# CITY PLANNING COMMISSION

APPLICATION: Special Permit to construct a single family dwelling under the deep lot regulation (Section 9 of Zoning Ordinance)

LOCATION: 3915 12th Avenue

APPLICATION: 1. Special Permit for deep lot development (Section 9)  
2. Variance to reduce the minimum width requirement from 20 feet to 18 feet for a single family dwelling (Section 2-E-26)

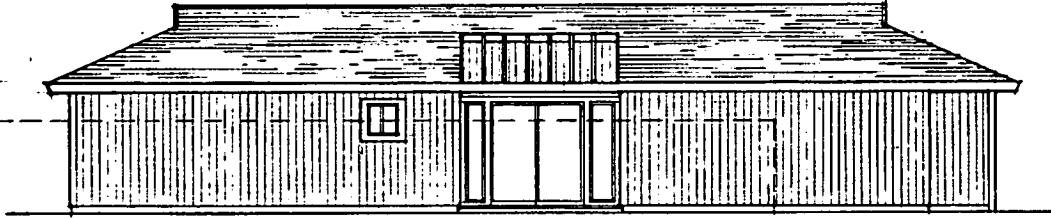
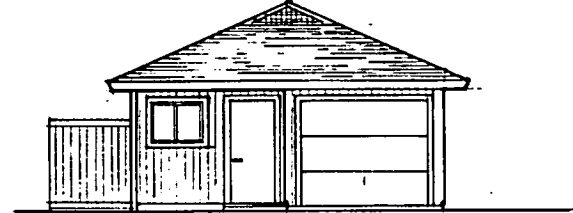
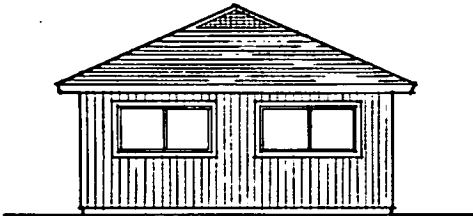
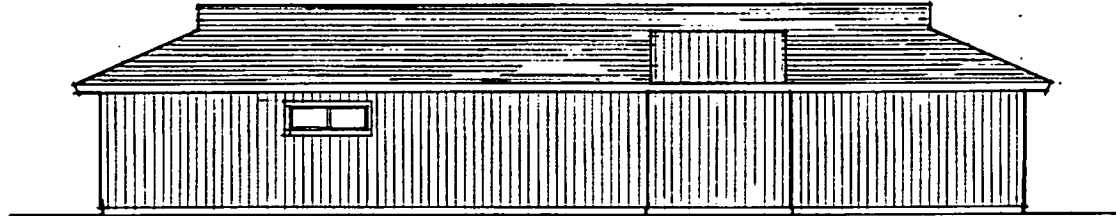
3. Staff suggests some minor modification to the design. The side elevations of the proposed structure are void of windows. Staff suggests additional windows be included along these side elevations to improve the appearance and provide relief to the 60 foot long walls. This will also improve the visibility of the outside yard area for security and safety purpose.
4. The subject site is presently developed with a single family structure on the rear of the site. Access is also provided to an adjacent land-locked parcel from the driveway on the subject site. Due to the excessive depth of this parcel, staff has no objections to the proposed deep lot development subject to conditions. The site is not capable of further subdivision.

1. The completed structure shall be reviewed and approved by the Planning Director prior to final inspection approval of the dwelling by the City Building Division.
2. The applicant shall submit revised floor plans and elevations indicating additional windows on the side elevations. Plans shall be submitted for Planning Director review and approval prior to issuance of a building permit.
3. The applicant shall comply with the deep lot regulations (Section 9) of the Zoning Ordinance.

Original Floor Plans  
and Elevations

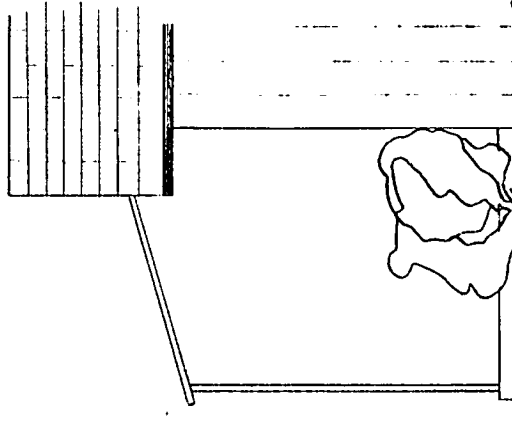
6. Staff has several concerns regarding the design and appearance of the proposed residential structure. Exhibit B is the applicant's original proposal (elevations) for deep lot development.

Revised  
Elevations

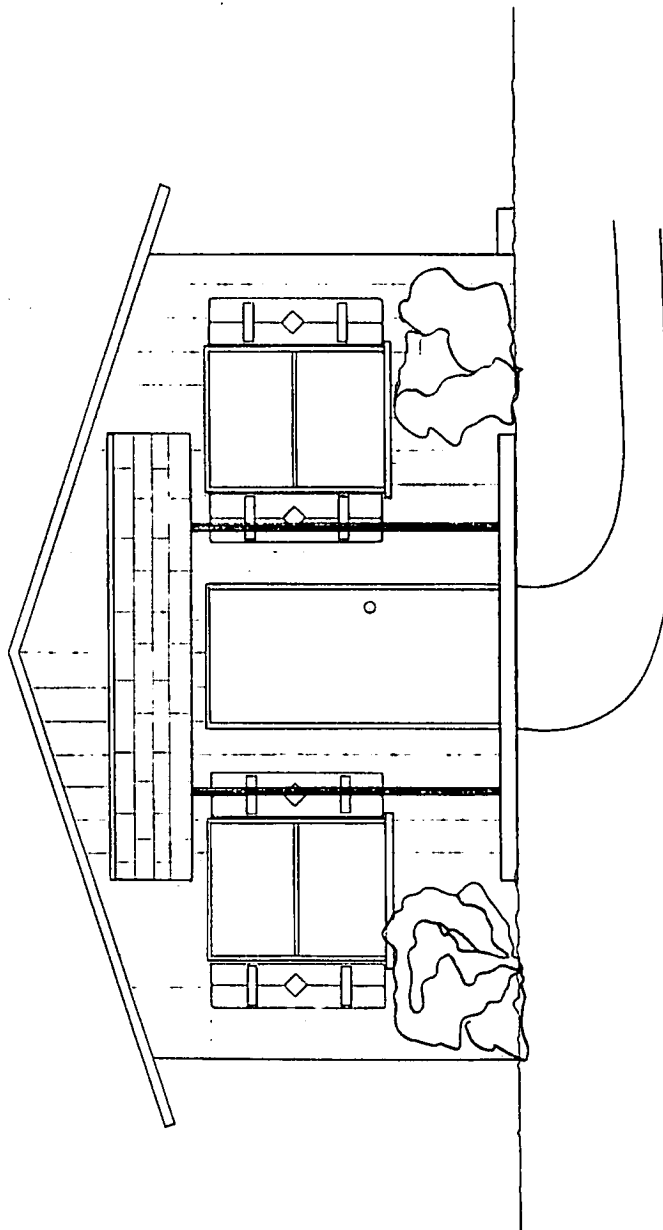
Staff indicated to the applicant that the design and appearance of the proposed dwelling needed redesign and enhancement. The applicant, therefore, submitted revised plans for the site indicating the addition of shutters, a front porch, curved walkway, and an increase in square footage to 720 square feet (Exhibits C and D). The applicant has also indicated that he is willing to plant shrubs in the front yard setback area. Staff, however, feels that these are minor cosmetic additions and there are still basic problems with the design (including width) of the structure and the proposed building materials. Staff believes that the structure, as proposed, will not enhance the appearance of the neighborhood and recommends denial of the project.

Exhibit D  
Revised Floor Plan

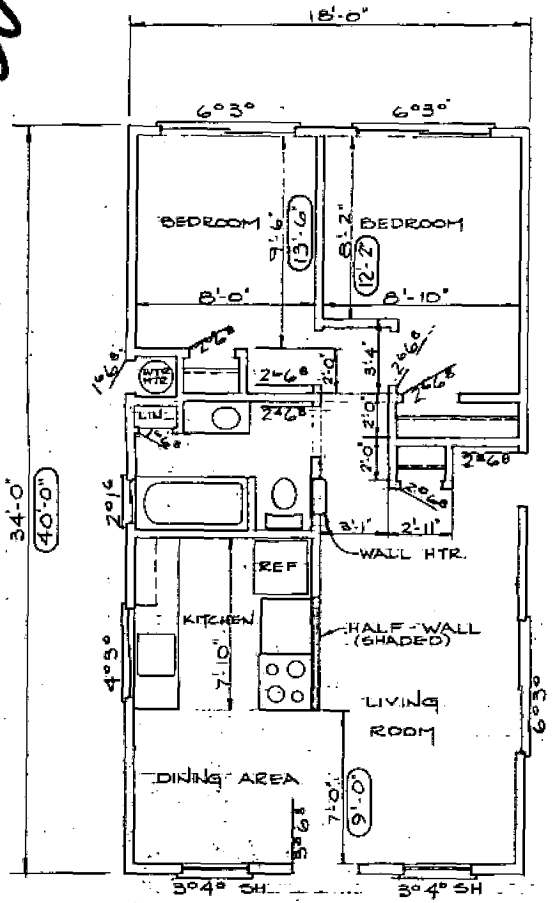
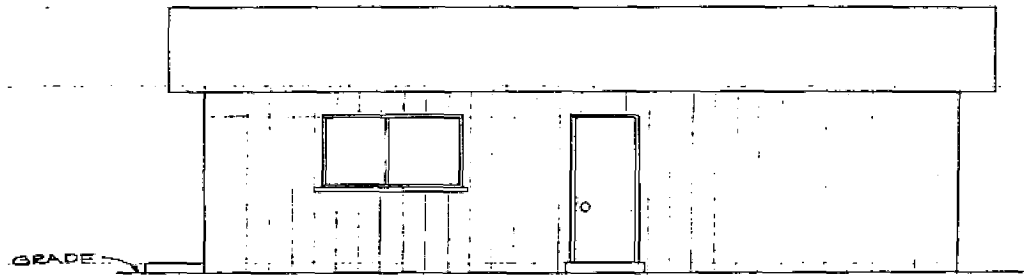
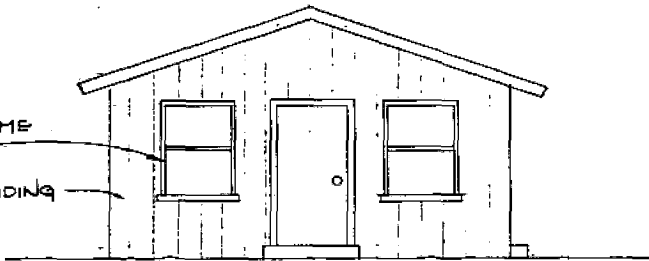
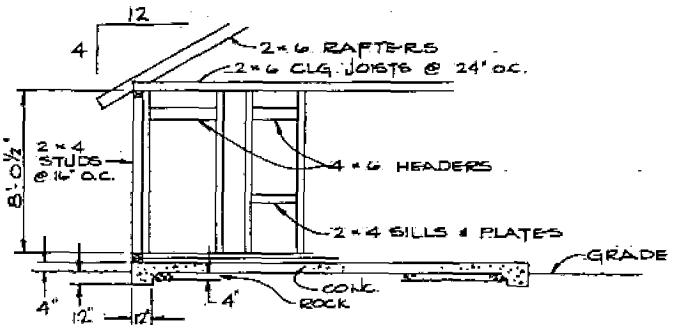
2. The subject site is located in the Oak Park Redevelopment Area and was reviewed by the Oak Park Project Area Committee at their December 7, 1983 meeting (Exhibit E). They recommended approval of the project if the following changes were made to the submitted plans:
  - a. Requested that the square footage of the structure be expanded to 900 square feet.
  - b. Requested that the square footage of the bedrooms be expanded to 10' x 13.5' and 10' x 12'.
  - c. Recommended that the width of the dwelling be 20 feet, as per Zoning Ordinance requirements.

On December 7, 1983, applicant, Mr. Smith presented revised plans to us. He was told these plans would be acceptable only if he increased the square footage from 720 square feet to 900 square feet and increase his bedroom size from 8 x 13½ & 8 x 12 to 10 x 13½ & 10 x 12.
